MEMORANDUM

SUBJECT: Resiliency review consultation services related to the East Arlington Mugar site

Weston & Sampson Engineers, Inc. (Weston & Sampson) is pleased to present this memorandum to the Arlington Land Trust to summarize climate resiliency considerations of the Thorndike Place proposed design at the East Arlington Mugar site (the “Site”) being developed by OakTree Development and designed by BSC Group.

Figure 9. FEMA FIRMette for Site

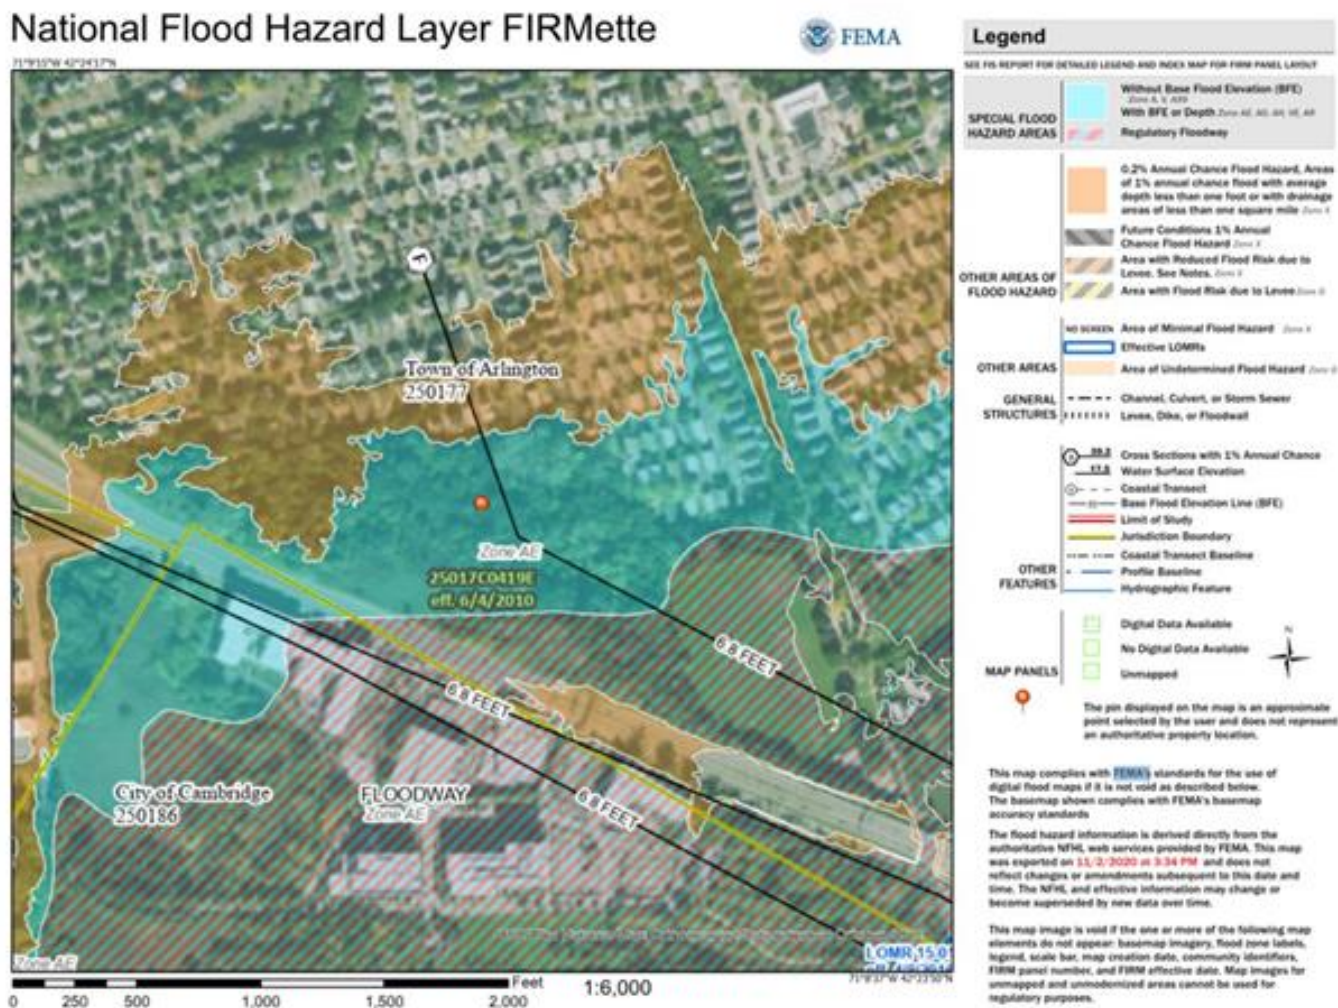
Alewife Brook (Little River)² created by FEMA, the 500-year elevation for the Site is 10.75 feet NAVD88. Furthermore, all of FEMA's elevations for the Site are based on data collected up to June 4, 2010, and do not consider SLR or SS effects due to climate change. The first floor living space for the Thorndike Place development is designed at an elevation of approximately 13 feet-NAVD88, making it suitable for projected SLR and SS effects, but the underground parking area is at a severe risk of flooding.

Figure 10. Map from the BH-FRM showing the 2070 1% Annual Chance Flood

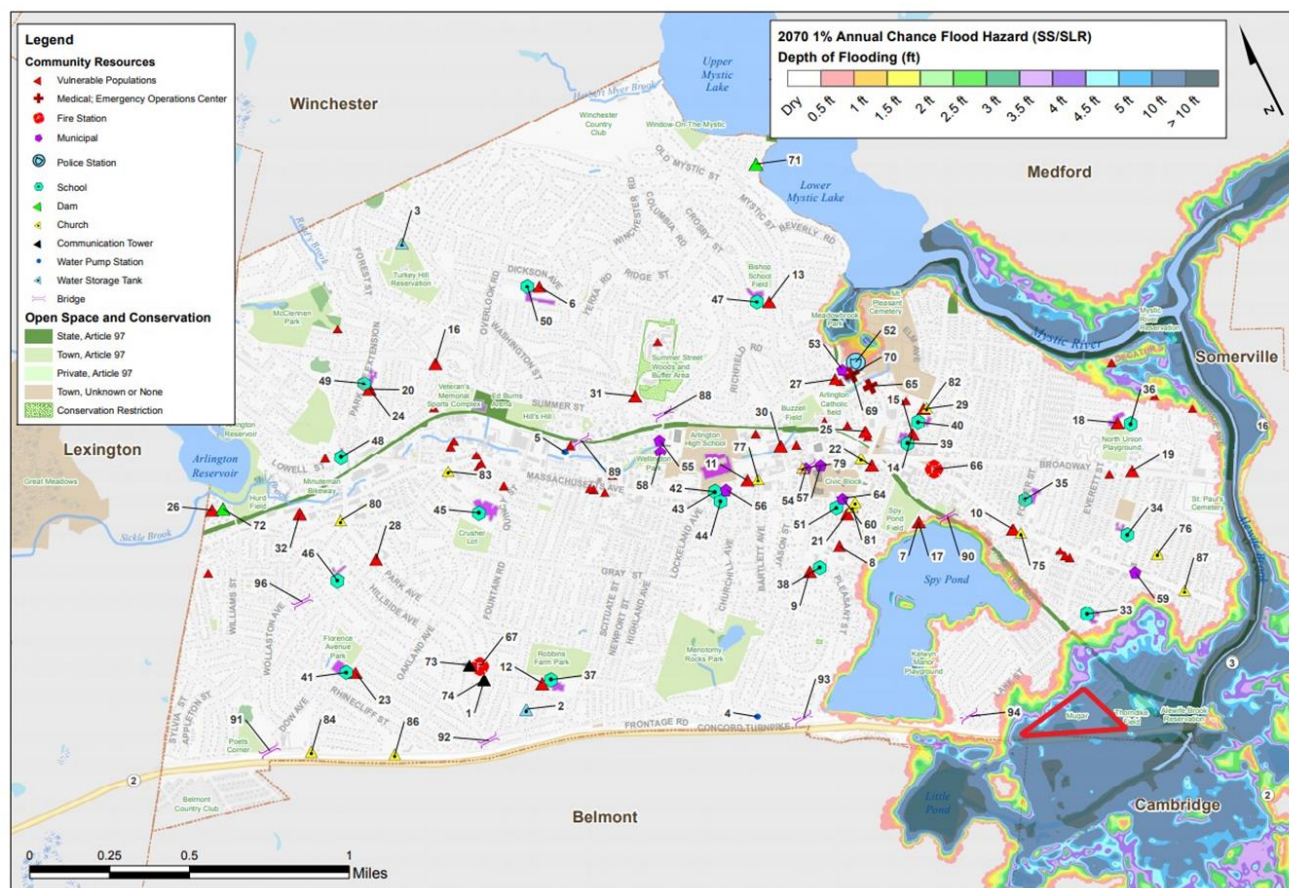
proposed development site, and the site is likely to experience a greater than 20% annual probability of flooding by 2070.³ The Department of Conservation and Recreation (DCR) is actively undertaking a Feasibility Analysis on raising and extending the AED and pursuing this effort in coordination with regional resiliency efforts. The timeline for these improvements is uncertain, which is why the Thorndike Place Development should consider these future flooding impacts. Figure 10 shows a map of the 1% annual chance flood depth projected throughout Arlington for 2070 by the BH-FRM, which was the model used in the Cambridge Climate Change Vulnerability Assessment. This map indicates a projected flood depth of at least 10 feet throughout the Mugar site.

Figure 11. Comparison of Total Storm Depths

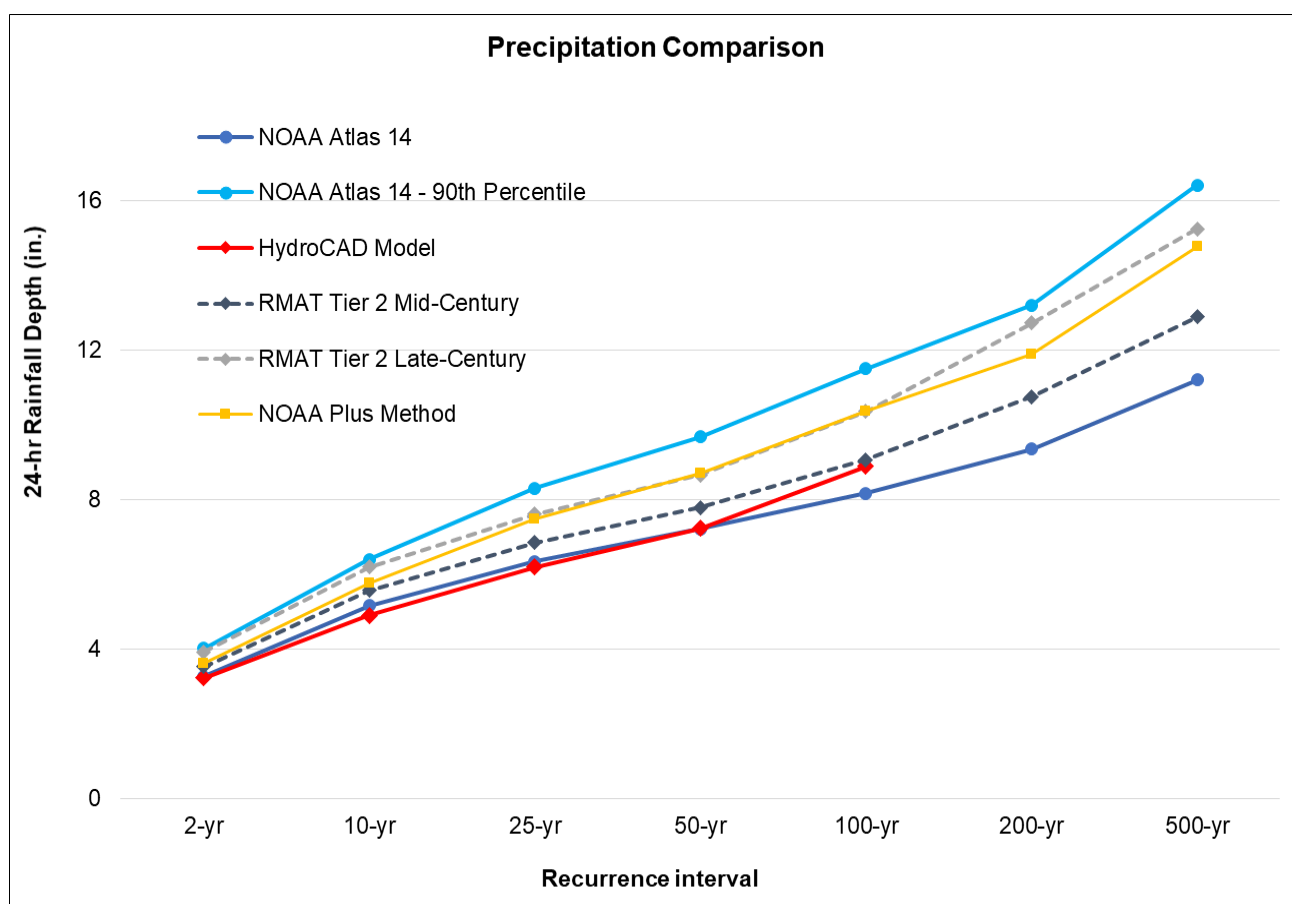
Climate resilient design for the average level of effort ("Tier 2"), as proposed by the RMAT Standards, include percent increases for NOAA Atlas 14 estimates. These percent increases for the mid-century (2030/2050) and late-century (2070/2090) show greater design storm depths than used for the proposed project. A comparative representation of the precipitation depths discussed in this memorandum is shown in Figure 11, with the corresponding values indicated in Table 1, below. It is recommended that these updated precipitation depths be evaluated within the HydroCAD model to appropriately design a stormwater management system at the Site that will be effective in the 2070s planning horizon.

2. Utilize updated 24-hr design storm depths in the HydroCAD model to appropriately design a stormwater management system that will be effective in the 2070s planning horizon. The RMA2 Tier 2 Methodology provides percent increases to the NOAA Atlas 14 design depths used in the current design of the Thorndike development. The efficacy of the proposed stormwater management at the Site should be assessed using the recommended RMA2 Tier 2 Late Century percent increases.

Figure 12. Arlington Land Surface Temperature Map, 2018

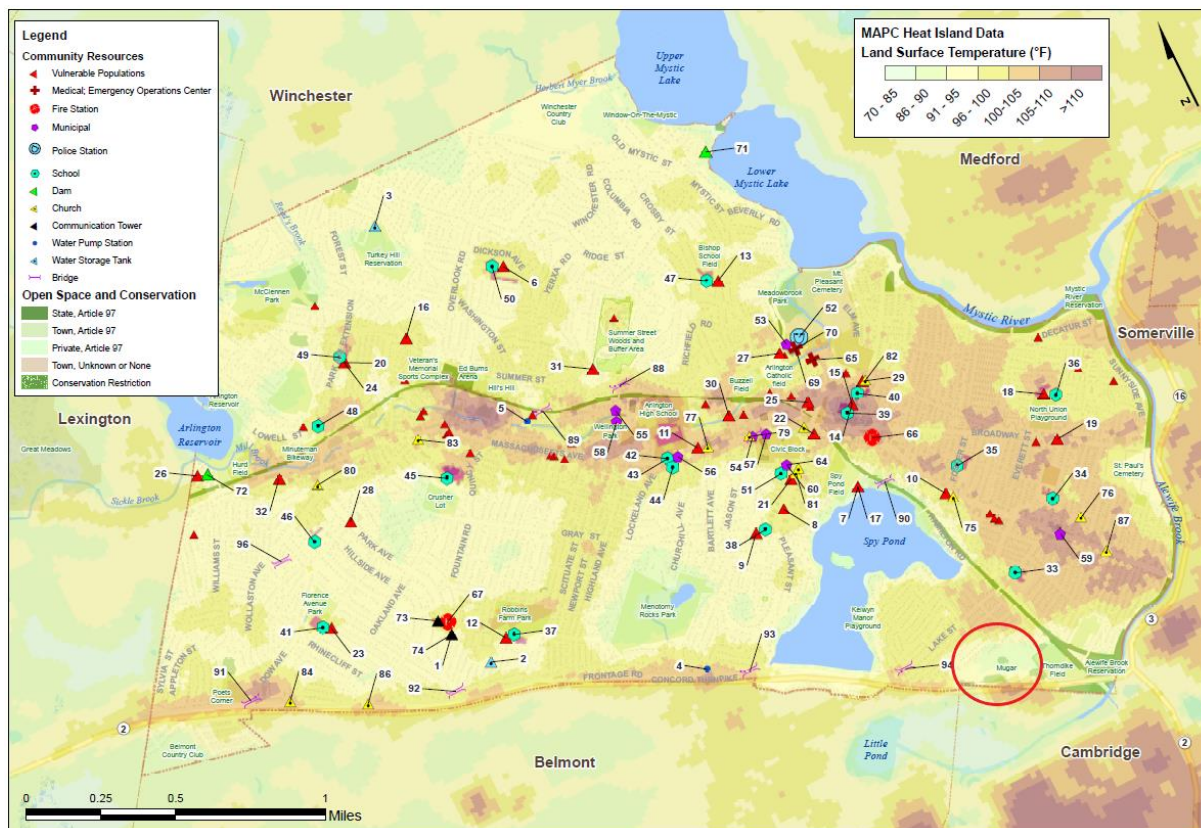
Review of available design documents for the Site does not indicate how development will change land surface temperatures or mitigate the already increasing urban heat island effect. Furthermore, the current Site design does not consider or propose methods to mitigate and protect against future projections for extreme heat.

Taken from the Town of Arlington Community Resilience Building 2018 Report, Figure 12 depicts the current heat island analysis for the Arlington area based on land surface temperature¹⁰. This figure demonstrates that the Site is one of limited areas within the Town that has lower land surface temperatures. The Cambridge CCVA further shows that ambient air temperatures are projected to increase through 2070, becoming dangerous to human health, worsening the situation for already vulnerable populations expected to be living on the Site¹¹.

5. Provide information on how development of the Site will change land surface temperatures to prevent exacerbating the already increasing urban heat island effect.
